AMENDMENTS TO THE DRAWINGS:

REMARKS

Fig. 9

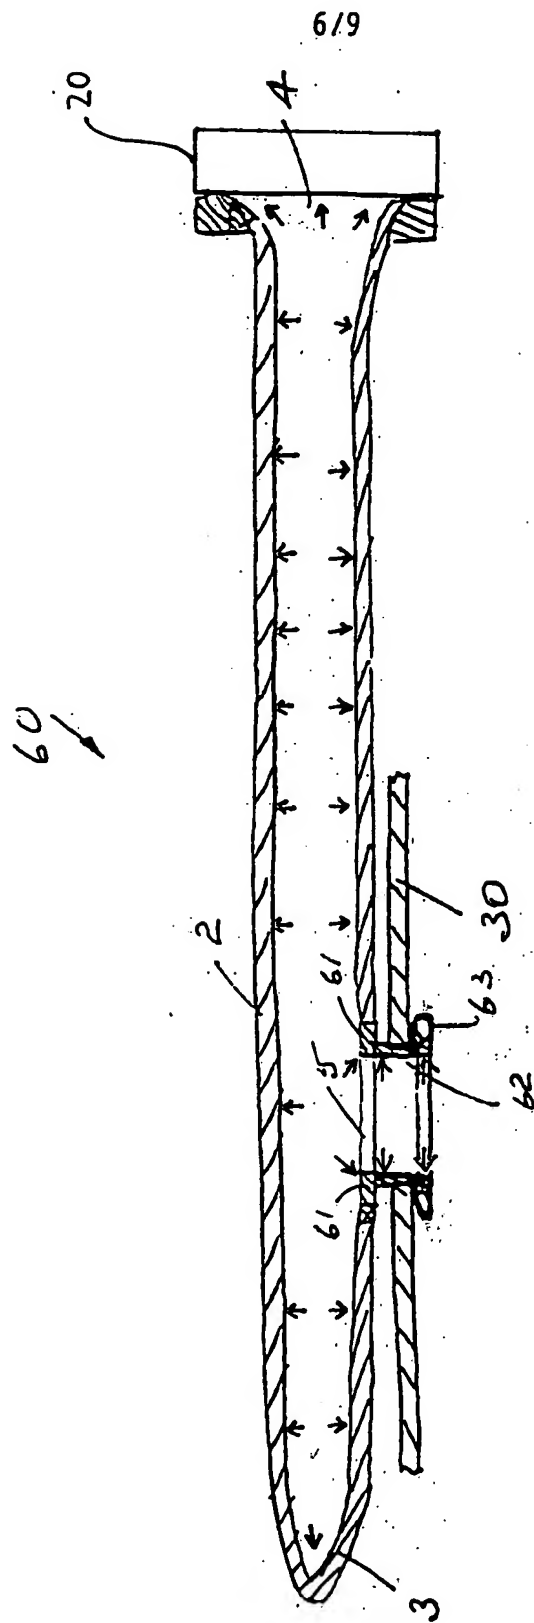
The attached replacement drawing sheet includes amendments to FIG. 9. Those amendments include adding the element identified using reference numeral 20, as well as adding arrows in an interior region of the element identified using reference numeral 2. The attached annotated sheet shows the amendments in redline.

On page 8 of the Office Action, the drawings were objected to under 37 C.F.R. § 1.83(b) as allegedly being incomplete. According to the Examiner's comments in the Interview Summary, and on pages 2 and 9 of the Office Action, the proposed amended version of FIG. 9 that was presented at the interview remedies the alleged drawing deficiencies, and is supported by the originally-filed application. The attached Replacement Drawing Sheet is based on the proposed amended version of FIG. 9, and thus, it remedies the alleged drawing deficiencies. Accordingly, Applicant requests reconsideration and withdrawal of the drawing objection.
